Title	PLANNING APPLICATION REPORT
Ward	Thames Ward
Planning Application Reference:	PL/25/1191 Full planning permission
Site Address:	Land at Meadow Road, Reading
Proposed Development	Full planning application for the demolition of existing and construction of employment units for flexible uses within E(g)(ii) and (iii), B2 and/or B8 of the Use Classes Order (including ancillary office provision) with associated enabling works, access from Meadow Road and Milford Road, parking and landscaping. Departure from the Development Plan - the following application does not accord with the provisions of the development plan in force in the area in which the land to which the application relates is situated
Applicant	CBRE Investment Management
Report author	Catrin Davies
Deadline:	25/11/2025
Recommendation	<p><u>Refuse</u> planning permission for the following reasons:</p> <p>1. The proposal would result in the provision of major employment-generating floorspace within a site allocated for housing in the Local Plan. The proposal would result in a non-conforming use on an allocated housing site which would be an inefficient use of the site and contrary to the wider strategic aims of the Local

Figure 7: South elevation proposed units 8-9 and 10-11

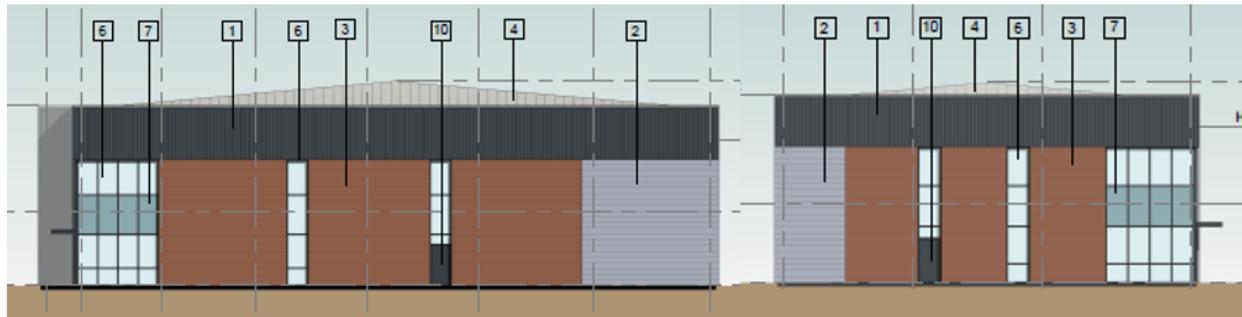
- 6.43. As can be seen from the above, the proposal would produce large, and almost completely blank frontages facing Meadow Road which is now wholly residential on its south side. This is not an acceptable design response even for the part of the site which is within the Core Employment Area. The visual shows very bulky, largely blank and unrelieved commercial buildings of an industrial nature, with very little in the way of relief to the streetscene, which would be harmful to Meadow Road. The narrow, tall, glazed portions which turn the corner of the buildings and the narrow area allowed for trees will do little to mitigate the visual impact of these industrial buildings or offer any animation to the residential properties opposite.

- 6.44. The architecture proposed is described in the applicant's DAS as essentially contemporary industrial, with a predominance of metal sheet cladding, aluminium doors and windows and brick-slip panelled areas. Roofing materials would appear to be metal also, with tall soffits to encircle the very low-angled roofs. Officers do not consider that controlling the materials would assist greatly in diffusing the harmful visual impacts of these large, inappropriate buildings.
